Interactive comment on “Hydrogeomorphological analysis and modelling for a comprehensive understanding of flash-flood damaging processes: The 9th October 2018 event in North-eastern Mallorca” by Joan Estrany et al.

The response of the questions and comments provided by Dr. Jorge Lorenzo-Lacruz will be addressed in a point by point format.

Fig. 3. Map of the north-eastern part of Mallorca Island, showing the catchments commented by Dr. Lorenzo-Lacruz with AEMET rainfall stations and MEDhyCON hydrometric stations.

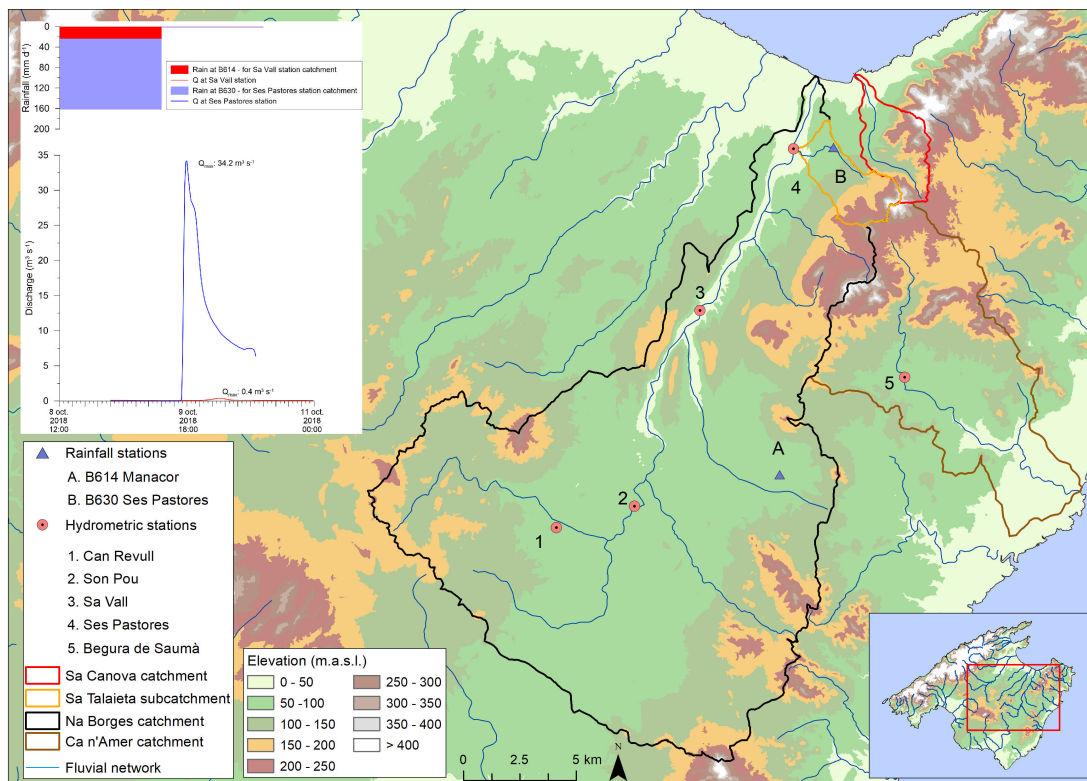
Regarding the following part of comment 4 “This highest rainfall recorded in the upper parts of the catchment would explain why the flash flood also occurred in the surrounding basins (barranc de Sa Canova and s’Ametllerar), which share the headwaters with the studied catchment”. We do not fully understand the aim of this comment. It is true

that a flash-flood also occurred in surrounding catchments, but with peak discharges much lower than the peak discharge recorded in the Begura de Saumà River (see Fig. 3 of this point-by-point document). The inset figure illustrates the rain fallen the 9th October 2018 in the middle and downstream parts of Na Borges River catchment as well the continuous streamflow calculated from the MEDhyCON Research Group at the (3) Sa Vall and (4) Ses Pastores hydrometric stations. Peak discharges were $>10 \text{ m}^3 \text{ s}^{-1}$ during the rain event of 9th October 2018, at least two order of magnitude lower than the peak discharge recorded in the Begura de Saumà River. With such intense rainfall recorded in the upper parts of the catchment as stated by Lorenzo-Lacruz et al. (2019), the MEDhyCON hydrometric station located in Ses Pastores (number 4 in Fig. 3 of this point-by-point document) probably experimented a flash-flood peak discharge of a similar magnitude to the one recorded in the Begura de Saumà River. Nevertheless, the peak discharge recorded by the MEDhyCON gauging station was one order of magnitude lower. In our opinion, this reinforces the spatial distribution of the rainfall obtained in our paper against the one presented by Jorge-Lorenzo et al. (2019).

Fig. 4. Comparison between the (a) Figure 6 of the Estrany et al. version in the Open Discussion stage and the (b) Reviewed Figure 6 that it will be submitted in the reviewed version of Estrany et al.

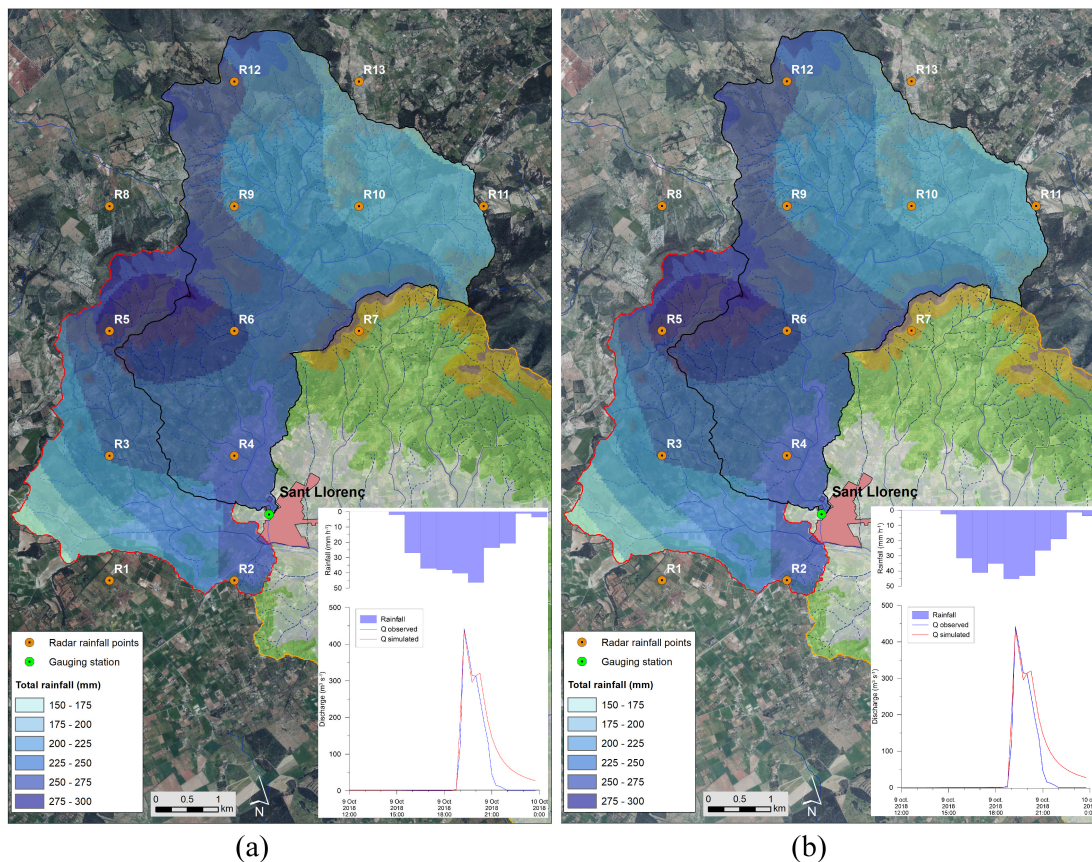
POINT 6 LORENZO-LACRUZ. Therefore, it is embarrassing to say that the “observed and modelled hydrograph and corresponding peak flow (442 cumecs)” showed in Figure 6 contains major flaws as: i) there is no observed hydrograph, ii) a glacio-hydrological model was used for a small Mediterranean watershed with low elevations and semiarid conditions, and iii) what is more surprising, the peak flow is reached one hour before the peak of rainfall. Is there any reasonable argument to defend such hydrological behaviour? We must again thank to Dr. Lorenzo-Lacruz about a warning on the observed hydrograph, despite the pejorative and abusive language. We address the three main concerns on Figure 6 from Estrany et al. MS, as follows:

iii) what is more surprising the peak flow is reached one or before the peak of rainfall. Is there any reasonable argument to defend such hydrological behaviour? We have revised the plotted hyetograph that represented the hourly average rainfall derived from all the radar points exposed in Fig. 6 of Estrany et al. MS. We have updated the hyetograph using only the rainfall radar points within the Begura de Saumà catchment. In the updated version of Fig. 6 of Estrany et al. MS, the peak of rainfall is at 19:00 h, 15 minutes earlier than the Q peak.

i) there is no observed hydrograph. In Figure 6, the observed and the modelled hydrographs are perfectly performed in blue and red lines respectively in Estrany et al. MS (see Fig. 4 of this point-by-point document). In addition, as we have stated in the previous points, continuous streamflow monitoring and the application of a calibrated and validated hydrological model as the GSM-SOCONT represents an accurate and precise methodological approach to investigate the hydrological response of this catastrophic flash-flood event. For this reason, the use of adjectives like “embarrassing” is totally unprofessional and unjustified in science communication and in any context. However, we will modify the width of these lines to improve the performance of one of the main results of Estrany et al. MS.

After this change, variables from Table 1 (rainfall and runoff variables of the flash flood) will be updated in the Estrany et al. MS, despite the fact that the differences do not modify the general patterns of the hydrological response of the catastrophic flash-flood. As a result, the time of maximum rainfall has been moved from 18.00 h to 19.00 h, whilst average total rainfall over the catchment derived from radar images has increased from 240 to 249 mm, IPmax average radar decreased from 46.4 to 45.3 mm h⁻¹, IP average radar increased from 24.01 to 24.91 mm h⁻¹ and runoff ratio decreased from 0.36 to 0.35. The updated rainfall and runoff values must be discussed in the same way as the previous values as changes were insignificant.
